Access Compliance Report Public Rights-of-Way (Curb Ramps)

Main Street: KELLOGG_DR		Cross Street: OLD_RANCH_RD		Location:	SE
ADA ID: RPAT210922095236	Ramp Type: Type 3 - Combination 1	Initial Pass/Fail: Fail	Overall Compliance: No	Severity Score:	19
Codes/Mitigation Info/Possible Solution			Field Measurements/Component Compliance

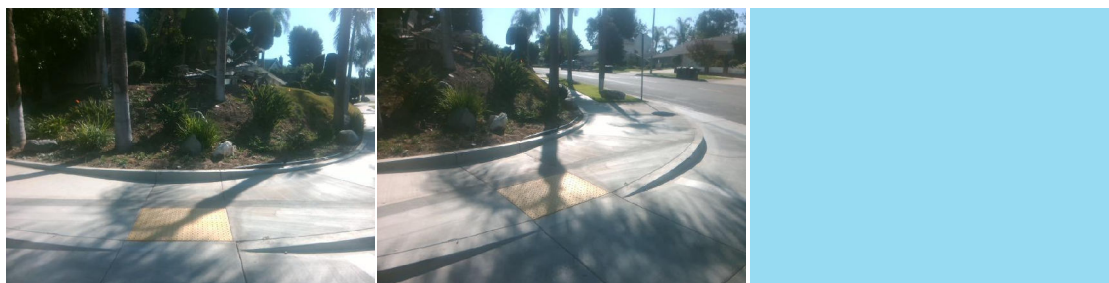
R304.2.2, R304.5.1, R304.3.2, STD 1115

Remove & Replace Curb Ramp With Two New Directional Ramps or Equivalent.
